DATE: May 14, 2014

AGENDA ITEM # 3

TO: Design Review Commission
FROM: Sean K. Gallegos, Assistant Planner
SUBJECT: 14-SC-07 – 827 Campbell Avenue

RECOMMENDATION:

SITE PLAN

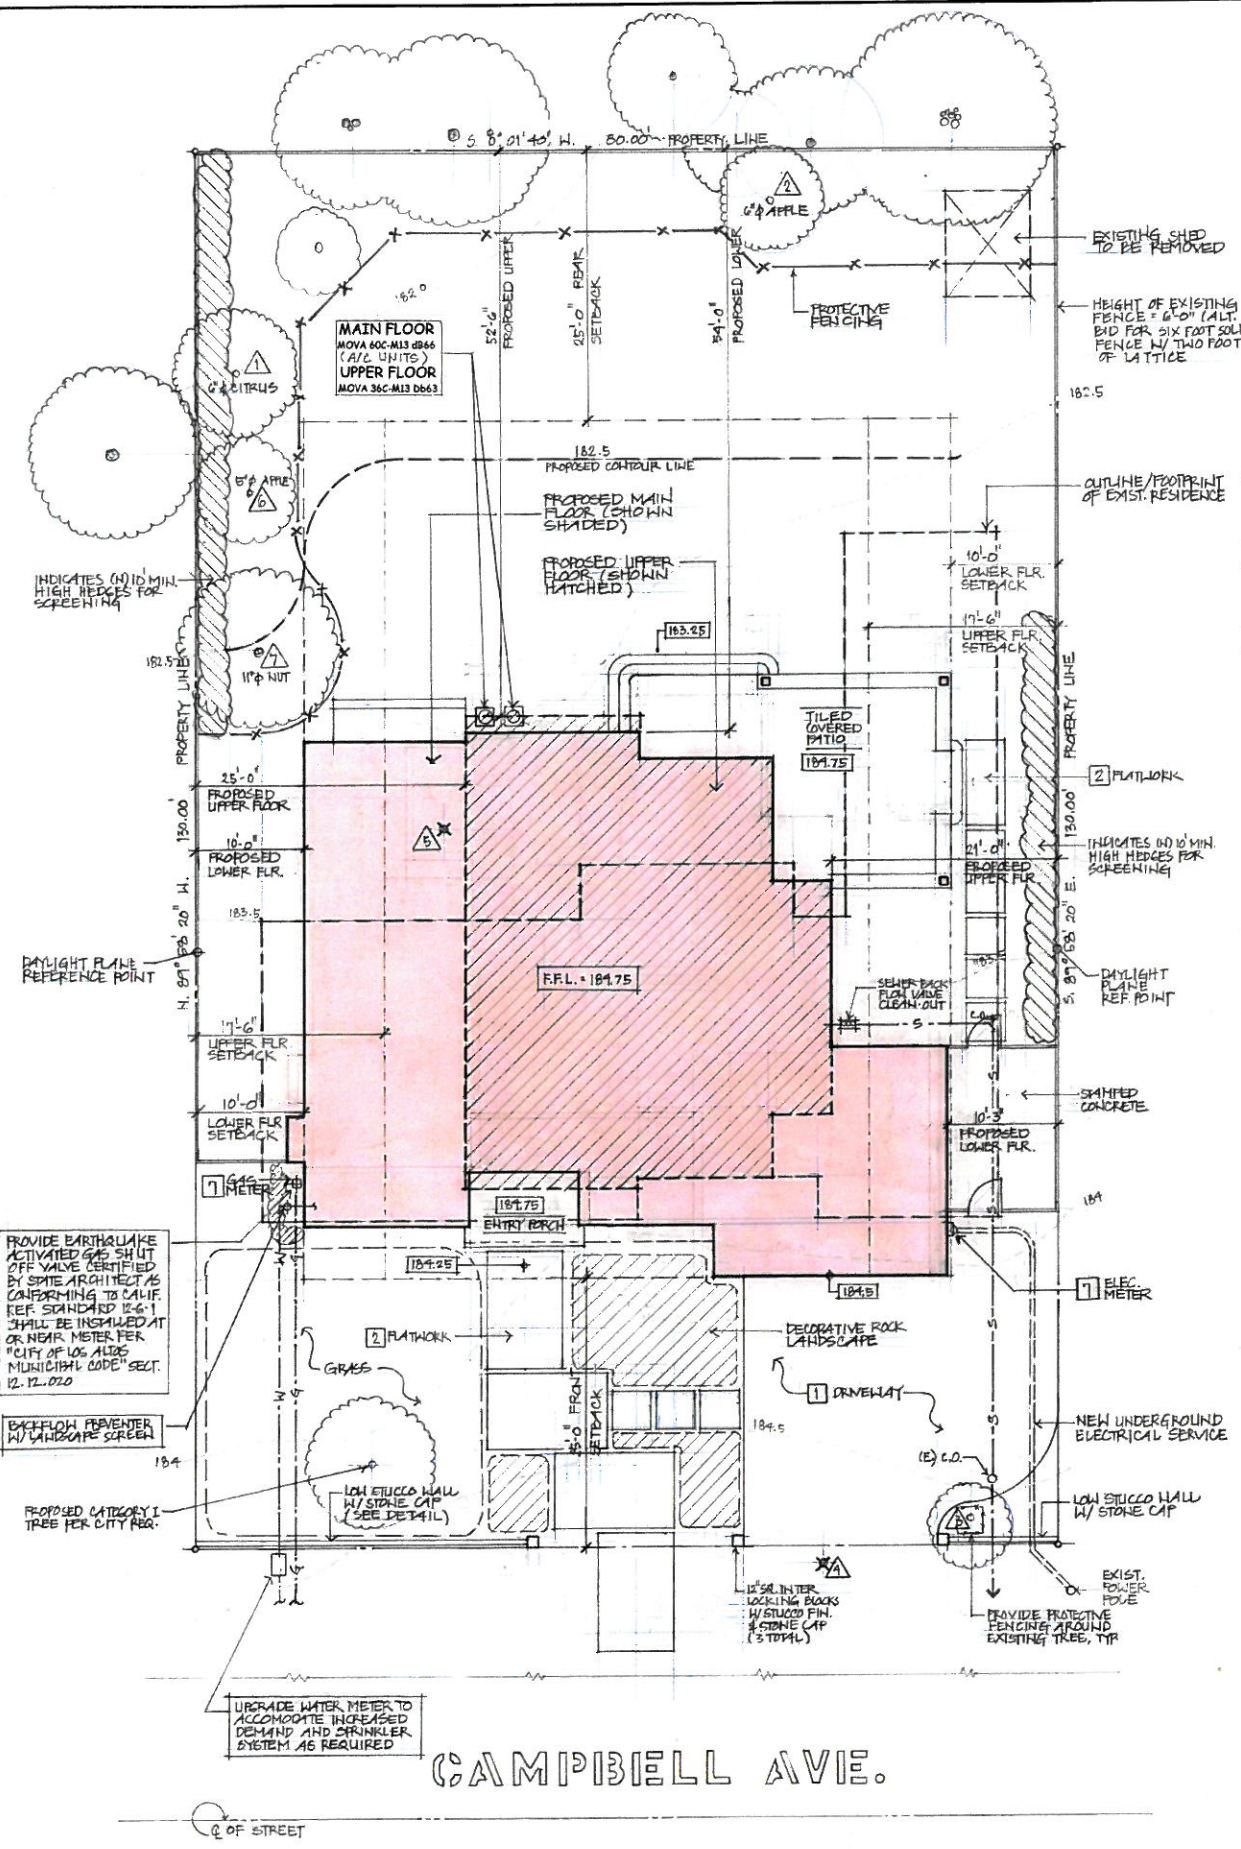
The Design Findings require that grade changes shall be minimized and will be in keeping with the general appearance of neighboring developed area. The applicant is proposing to re-contour the rear yard to add approximately six inches to the rear along the north side. Since the grading and drainage plan differs from the architectural site plan, these plans should be correlated to maintain a practical grade. In order to ensure that grade changes shall be minimized, staff recommends that the Design Review commission provide the following direction:

- Revise the site plan and grading and drainage plan to determine whether inconsistencies correlate with a minimal practical grade change for the site.

construction. The proposal removes the non-conforming fence in the front yard and replacing it with a new low stucco wall. However, the landscape plan should include the paving and landscaping in the right-of-way, and the driveway should be shown connected to the street. In order to ensure that there is minimum impervious cover and maximum erosion protection, staff recommends that the Design Review commission provide the following direction:

- Provide landscaping and street shoulder in the landscape plan consistent with the City's Shoulder Paving policy SU-22.

As previously proposed, there are five trees (trees Nos. 1-3 and 6-7) on the property to be retained by the applicant. As indicated in the landscape plan, medium to fast growing evergreen screening trees will be planted along the left (north) side yard, right (south) and rear (east) yard property lines to mitigate privacy impacts. Therefore, as designed and with the recommended conditions, staff finds that the project maintains a reasonable degree of privacy. A condition has been placed on the project to provide tree protective fencing for the retained trees on the site.

The revised plans ensure that grade changes will be minimized and will be in keeping with the general appearance of neighboring developed area. The applicant is proposing to re-contour the rear yard to add approximately six inches to the rear along the north side. The grading and drainage plan have been revised to be consistent with the architectural site plan.

FRONT ELEVATION
1/4" = 1'-0"

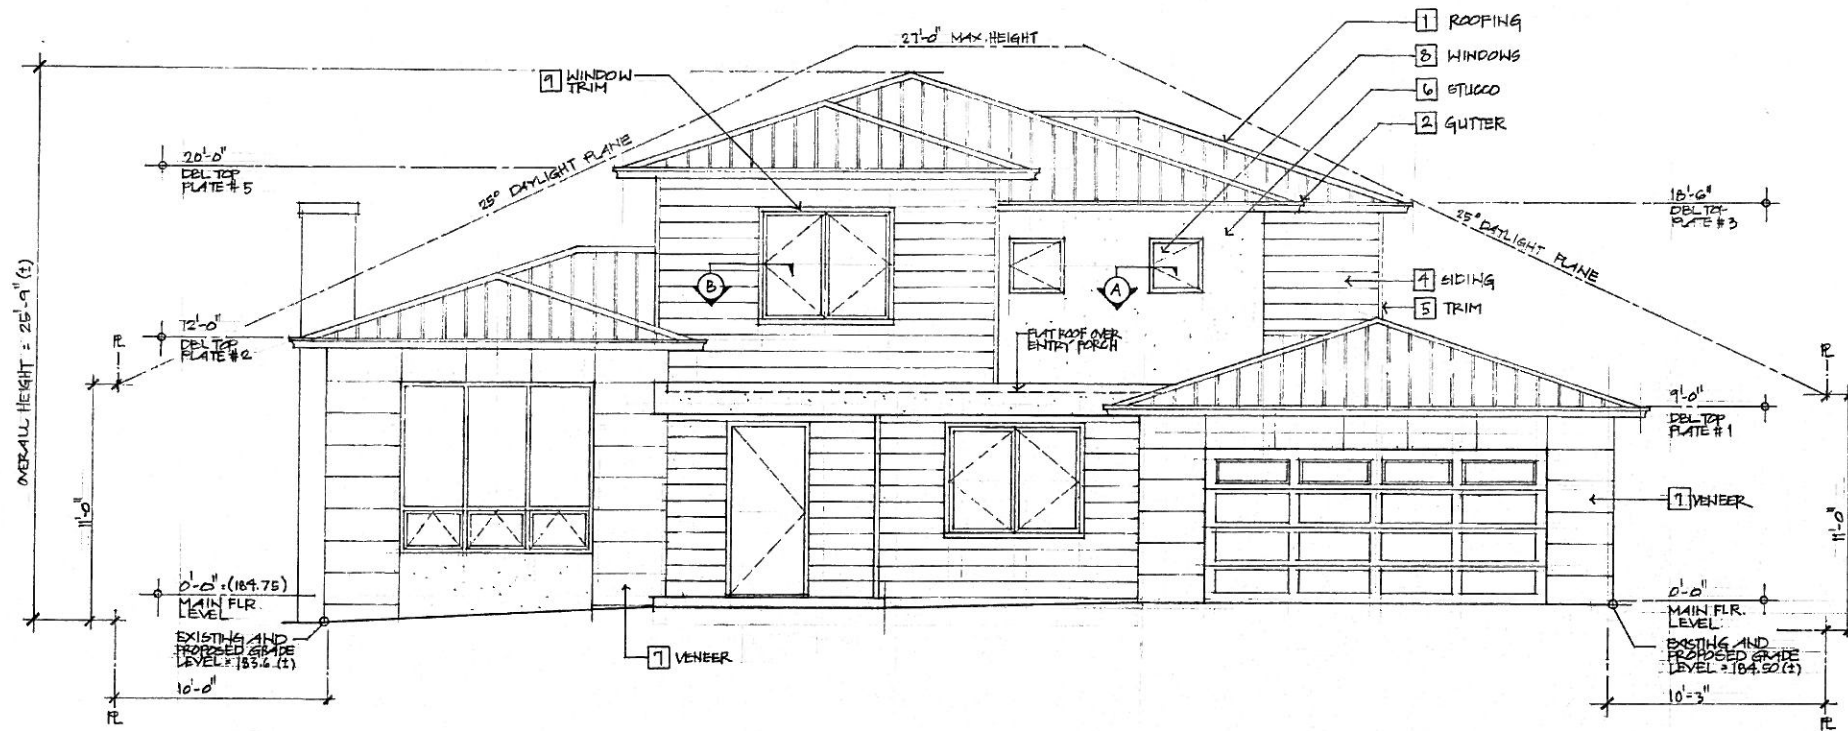
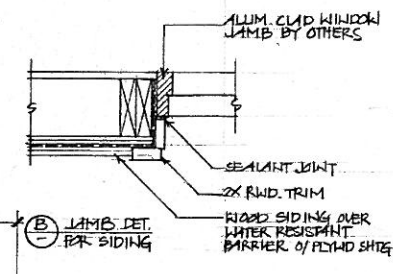
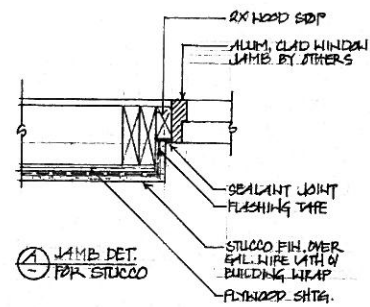
Staff is concerned that the proposed 12-foot tall eave line of the living room and dining room is substantially higher (approximately three feet) than the eave of the house to the left of the property may be an abrupt change for the neighborhood. Also, this element has a stone veneer, which contributes to its bulky appearance. Although the house meets the daylight plane, the eave heights appear as tall first story elements and contribute to the appearance of bulky and out-of-scale design elements. This contrasts with the lower walls of the adjacent structures and the neighborhood.

- Reduce prominence and height of single-story walls areas at the side and front elevation for the living room and dining room area of the structure.

In response to the Commission's action, the applicant revised the design of the project. The design changes include lowering the first-floor plate height of the living room and dining room from 11 feet to 10 feet. Additionally, the second story eave height was reduced from 10 feet to nine feet, six inches. In addition, the applicant has removed the stone veneer material from the facade, except for the entry alcove. The reduction of the eave heights and modification of building material helps to reduce the general bulk of the house and the taller living room element.

The application has been revised to address this concern by lowering the height of the living room dining room portion of the residence 1 foot. This makes the height of the structure relative to the home at 524 Harrington consistent with the height relationship between of the two story home at 538 Harrington which also adjoins the corner property. This is demonstrated by the street profile diagrams submitted with this application.

RIGHT ELEVATION
1/4" = 1'-0"

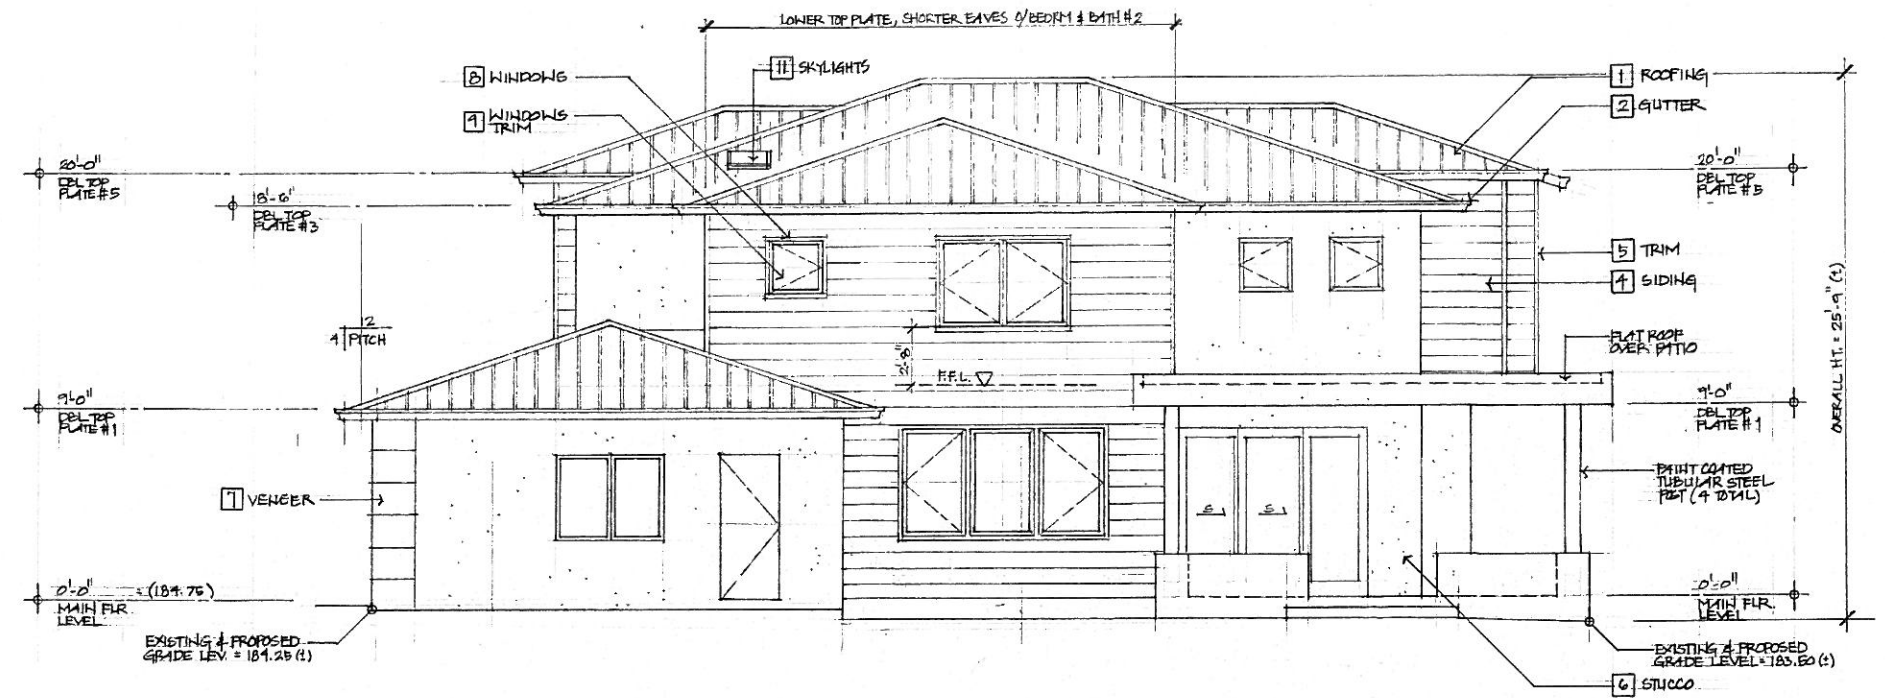
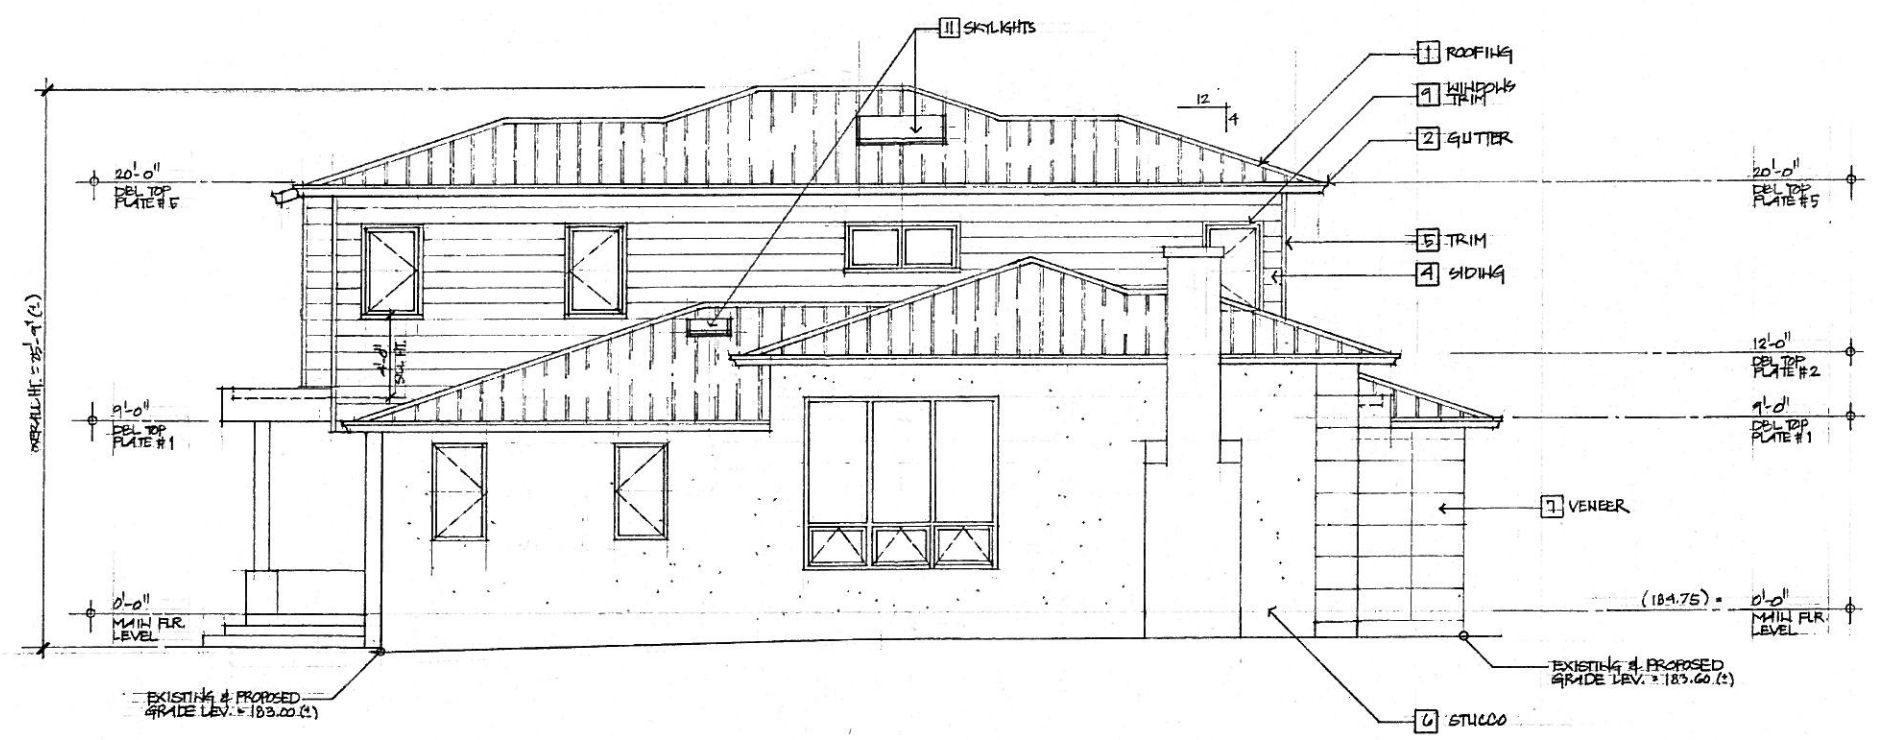
On the left side elevation of the second story, there are four windows: two located in the master bedroom with four-foot sill heights, one located in the stairwell with a six-foot sill height and one located in a bedroom No. 3 with a four-foot sill height. Due to their placement and sill heights, the proposed second story left side elevation windows do not create unreasonable privacy impacts.

On the right side elevation of the second story, there are four windows: two windows in the master bathroom with four-foot, six-inch, sill heights, one window in bedroom No. 3 with a two-foot, eight-inch sill height, and one window in bathroom No. 2 with a four-foot, six-inch sill height. Bedroom No. 2 window may create a privacy impact due to direct views into the adjacent residence and yards. The applicant has worked with staff to incorporate fast growing evergreen screening along the right property line. In order to mitigate unreasonable privacy impacts, a condition is required ensure a faster growing evergreen screening will be planted along the right side property lines.
